ADDENDUM NO. 2
TO
CONTRACT DOCUMENTS

2020 CARSON RIVER BANK STABILIZATION PROJECTS

CARSON VALLEY CONSERVATION DISTRICT

November 4, 2020

LOG VEIN DETAIL

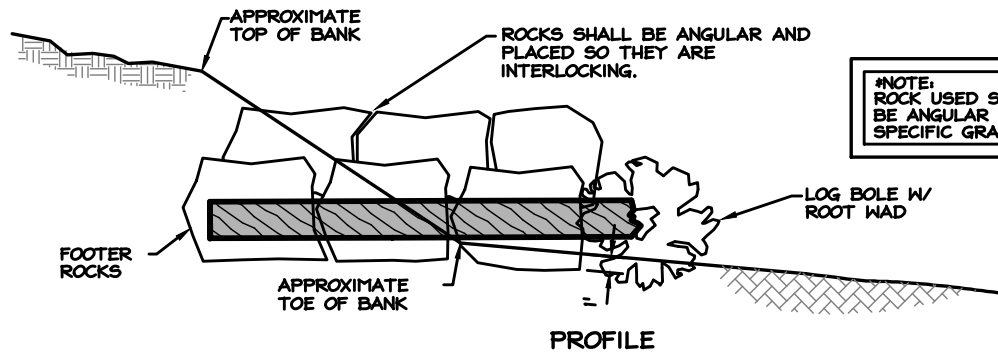
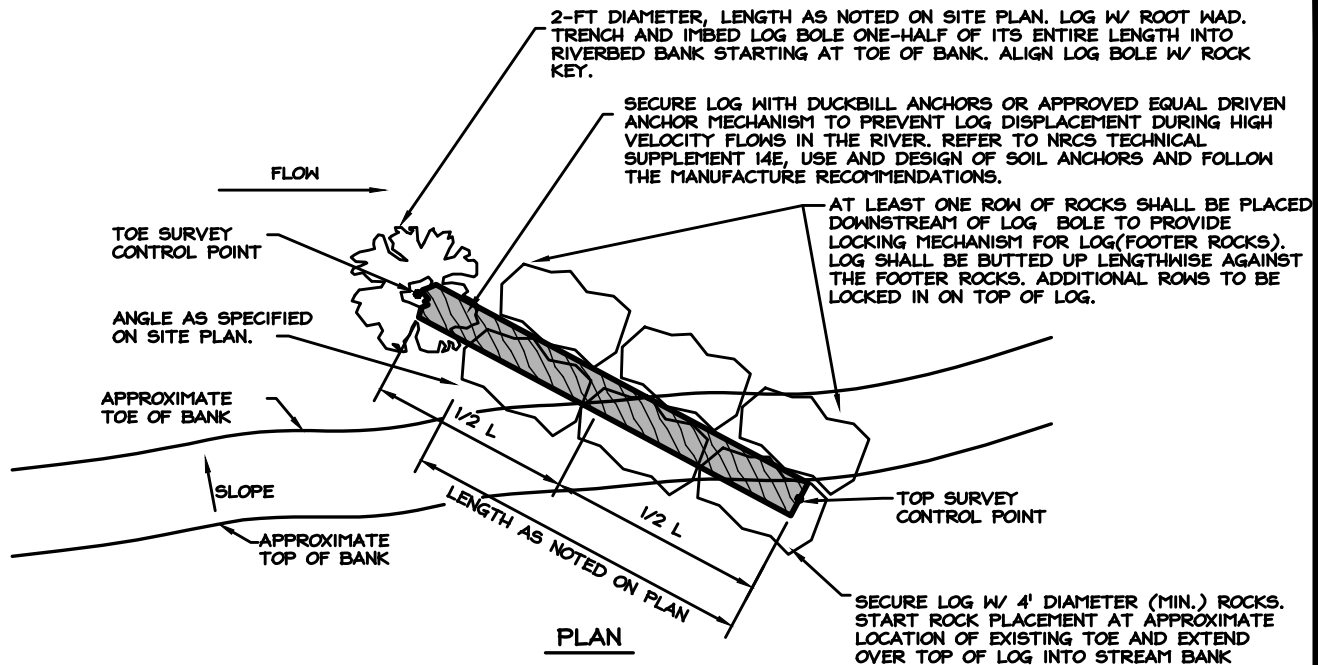
Replace Log Vein Detail shown on Sheet C11 with attached. The detail included in the improvement plans issued for bidding did not include following construction note.

“SECURE LOG WITH DUCKBILL ANCHORS OR APPROVED EQUAL DRIVEN ANCHOR MECHANISM TO PREVENT LOG DISPLACEMENT DURING HIGH VELOCITY FLOWS IN THE RIVER. REFER TO NRCS TECHNICAL SUPPLEMENT 14E, USE AND DESIGN OF SOIL ANCHORS AND FOLLOW THE MANUFACTURE RECOMMENDATIONS.”

Except for above-mentioned note, no other changes were made to this detail.
